PEER REVIEW MEMO

TO: Rod Bailey (Bell Road Limited Partnership) **DATE:** 24 March 2026
FROM: Brad Scarfe **PROJECT NO.:** J001051
COPY: Matthew Kerse (Maven)
SUBJECT: Wairakei South Fast Track – Independent Flood Modelling Peer Review (v2.2)

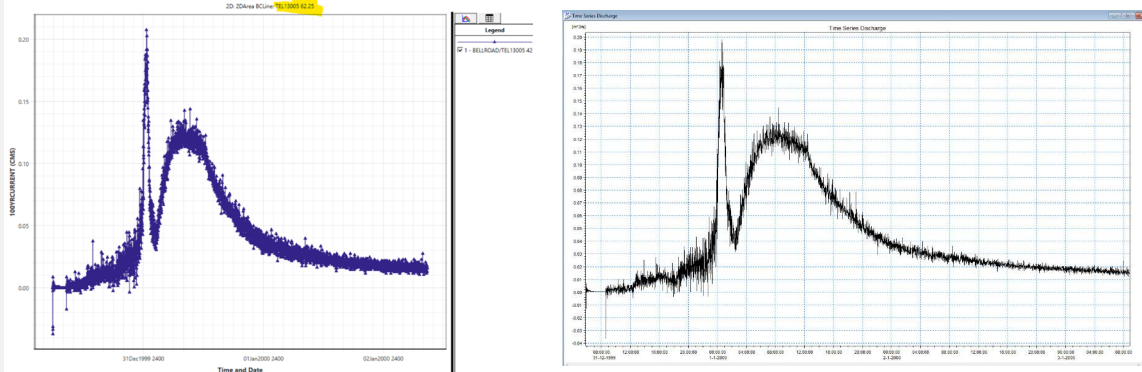
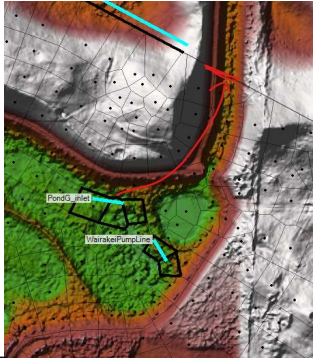
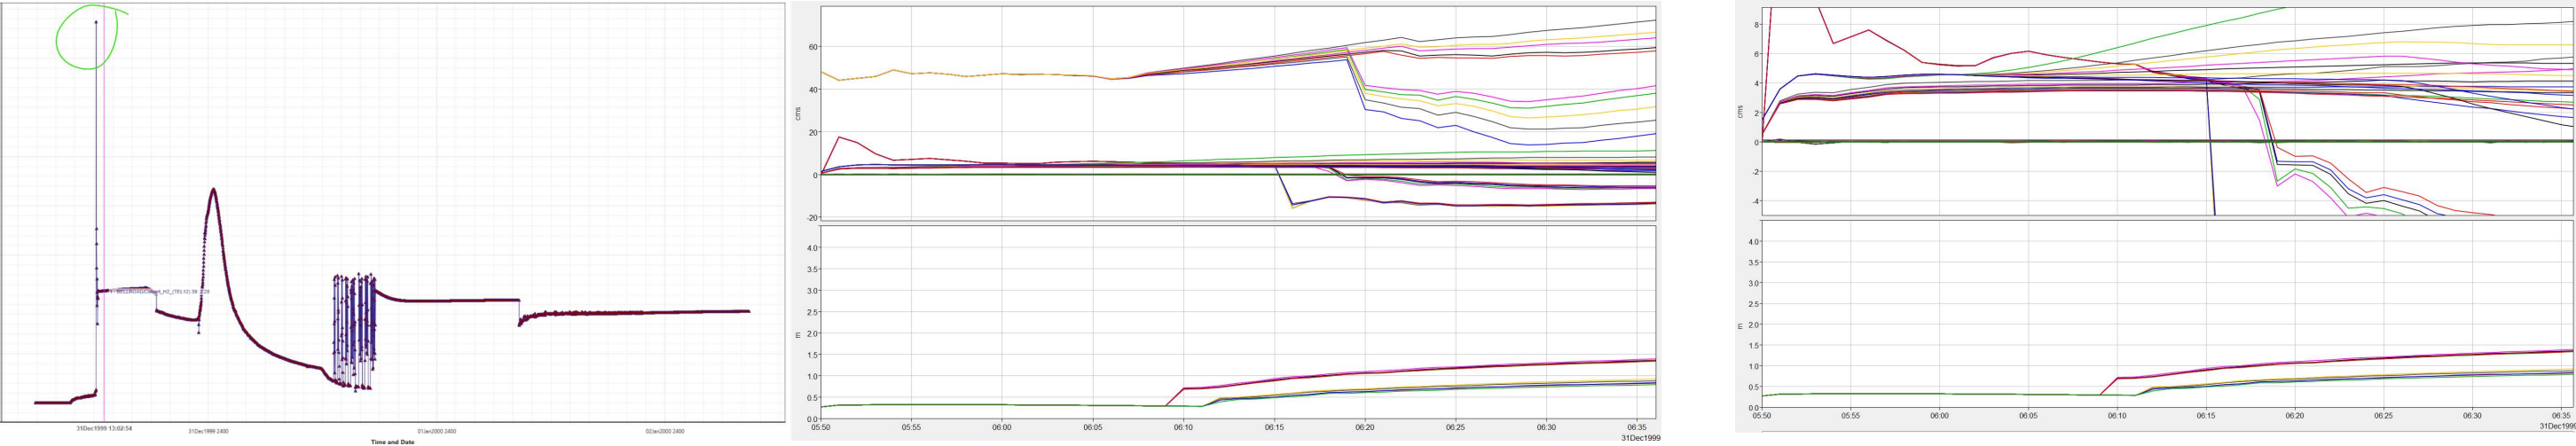
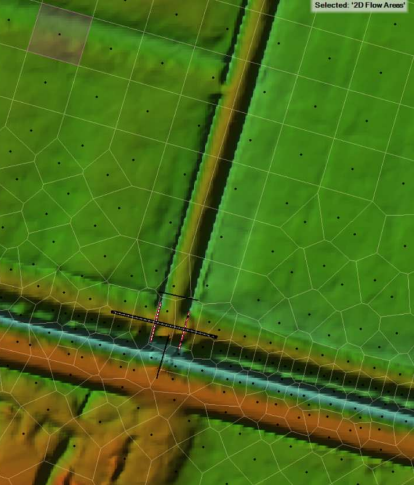
5	20-year return period - current climate (0.13 m SLR #) with and without development	As the long-term mitigation is unknown it cannot be determined whether the long-term mitigation will have an adverse effect under the present climate condition. Assessment of effects of the mitigation (including volume, level, extent, and duration etc) on private property and infrastructure in rural and urban area to show no increase of flooding due to the flows generated by the proposed development (determining if between a 10yr and a 50yr there may be adverse effects).
6	20-year return period - 3.68°C climate change (1.6 m SLR) with and without development	Assessment effects of the mitigation (including volume, level, extent, and duration etc) on private property and infrastructure in rural and urban area to show no increase of flooding due to the flows generated by the proposed development (determining if between a 10yr and a 50yr there may be adverse effects).

3

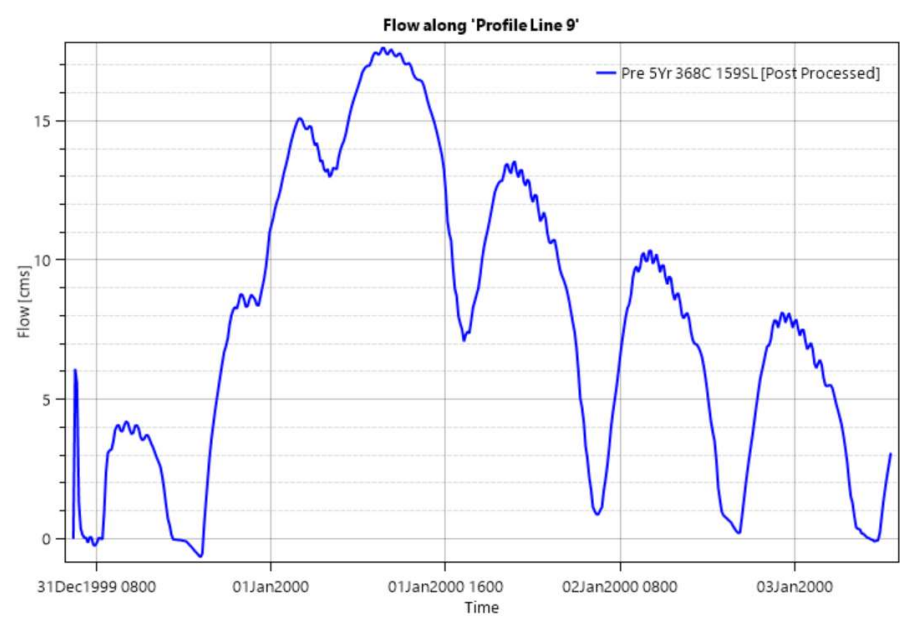
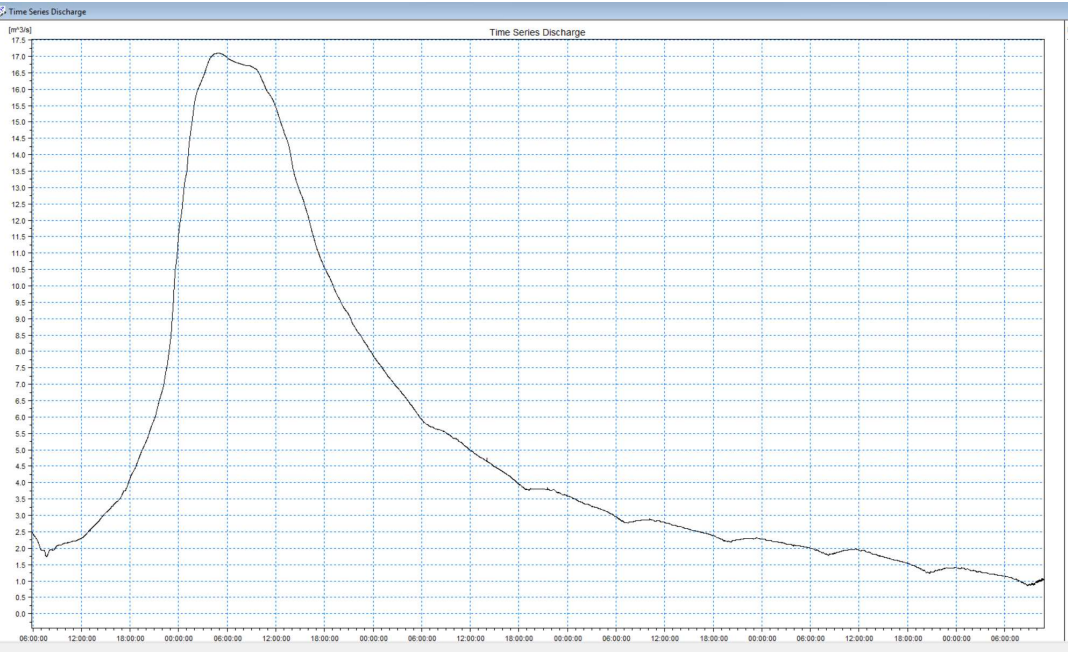
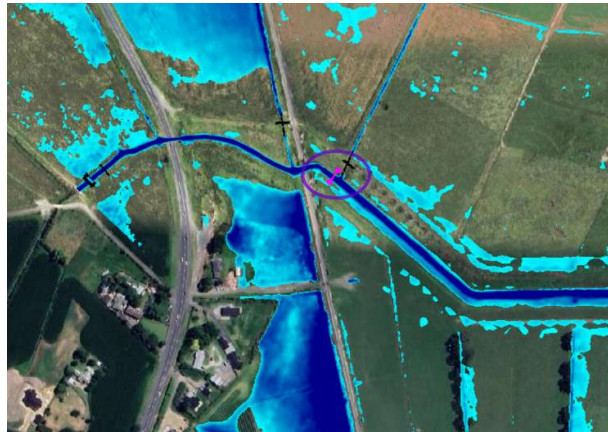
US Kopuaroa : (17.1 m3/s in MIKE vs 17.6 m3/s in HEC)

Time Series Discharge Flow along 'Kopuaroa_confluence'	US Kopuaroa confluence (21.7 m3/s in MIKE vs 22.2 m3/s in HEC)
Time Series Discharge Flow along 'Profile Line 7'	TEL Bell RD (5.4 m3/s in MIKE vs 4.4 m3/s in HEC)

4

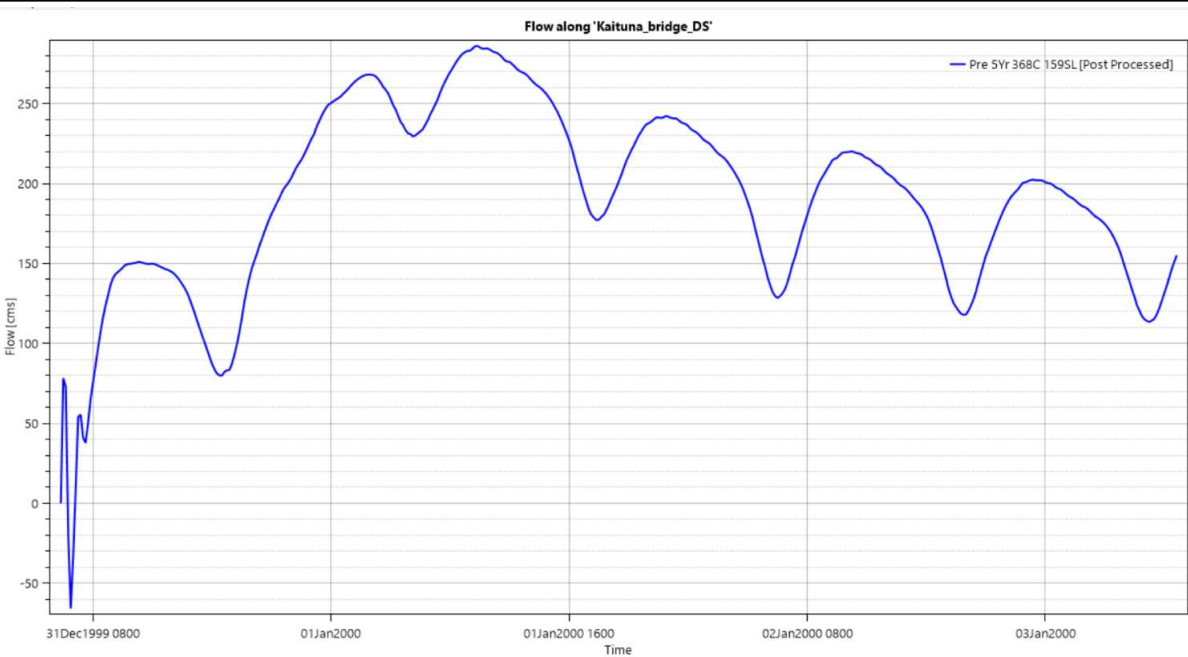
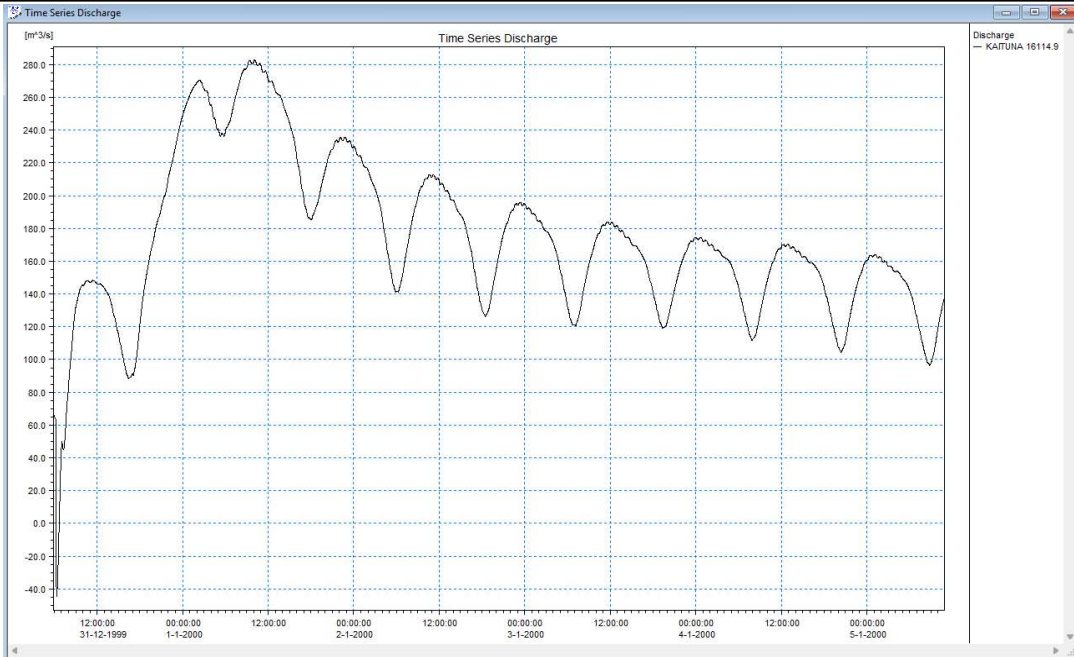
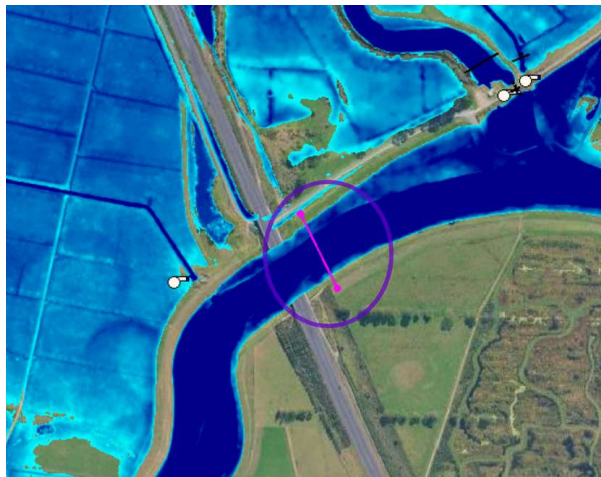
DS of bridge - Kaituna river : (283 m3/s in MIKE vs 286 m3/s in HEC).

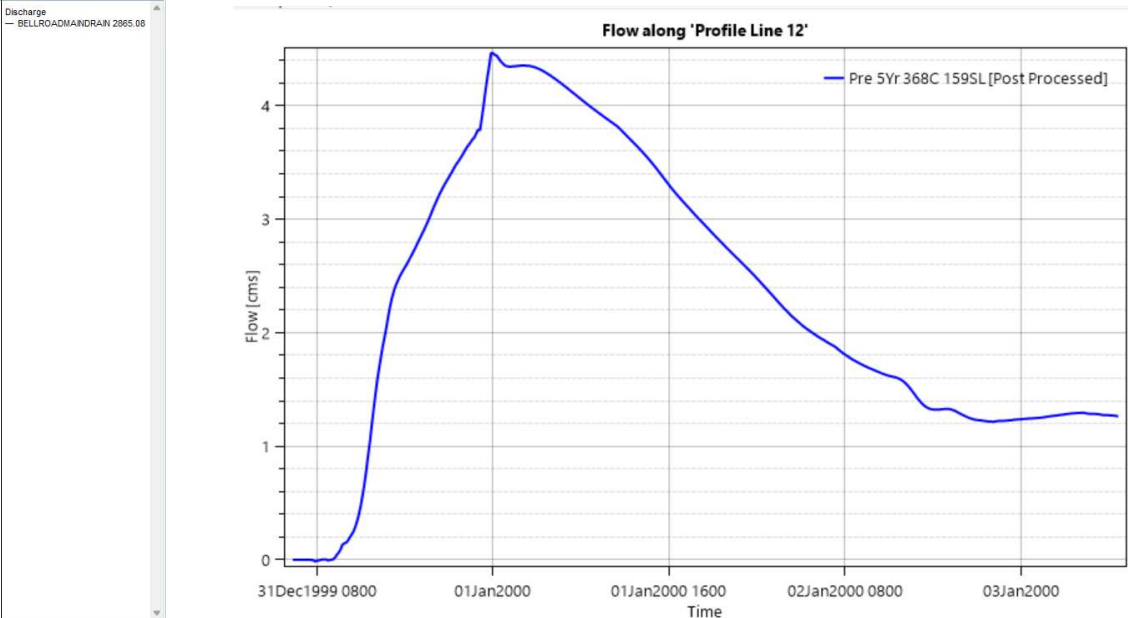
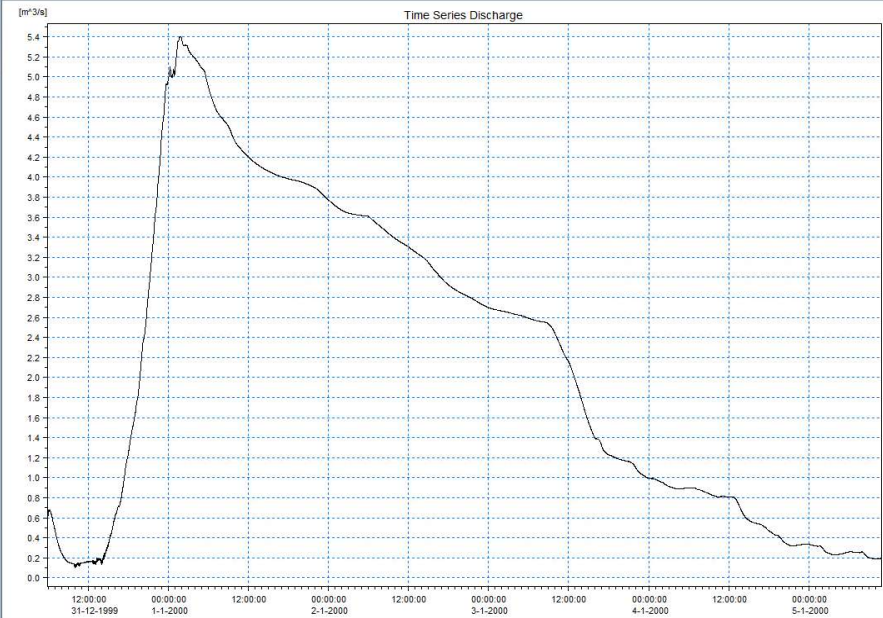
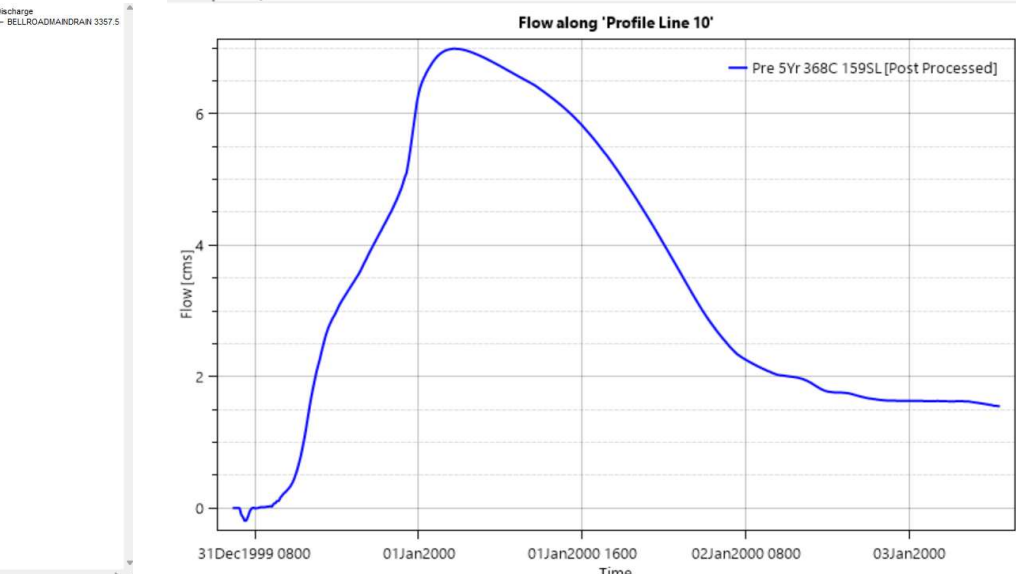
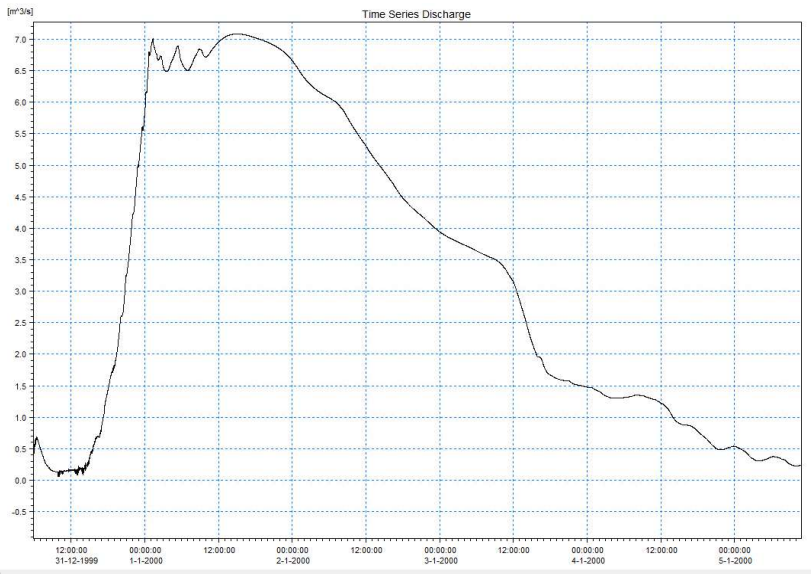
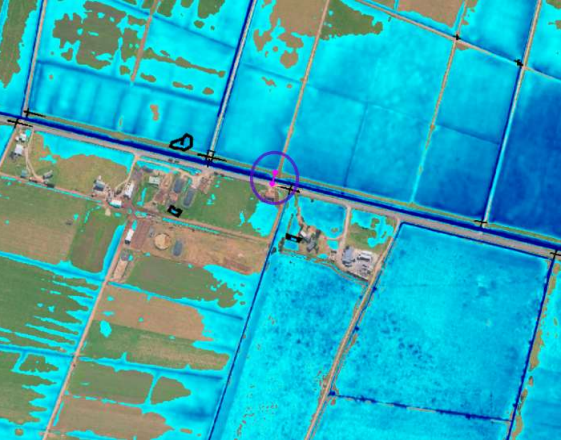
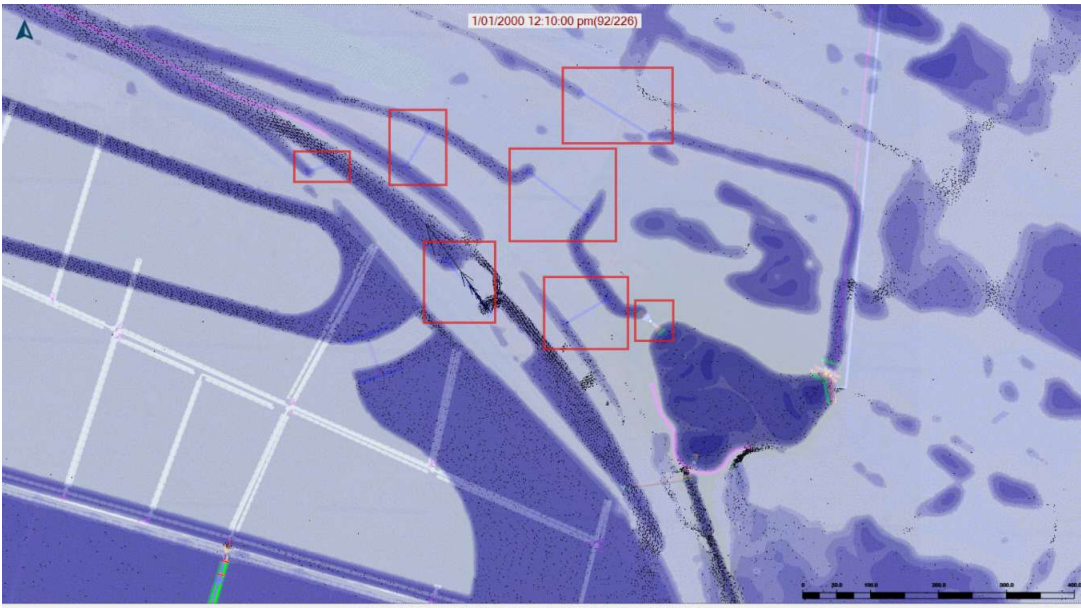
Bell Rd Main Drain 2072.9 : 8.1 m3/s in MIKE vs 5.6 m3/s in HEC.

Bell Rd Main Drain US development area: 5.4 m3/s in MIKE vs 4.5 m3/s in HEC. 
6		Bell Rd Main Drain inside development area: 7.1 m3/s in MIKE vs 7 m3/s in HEC. 
7
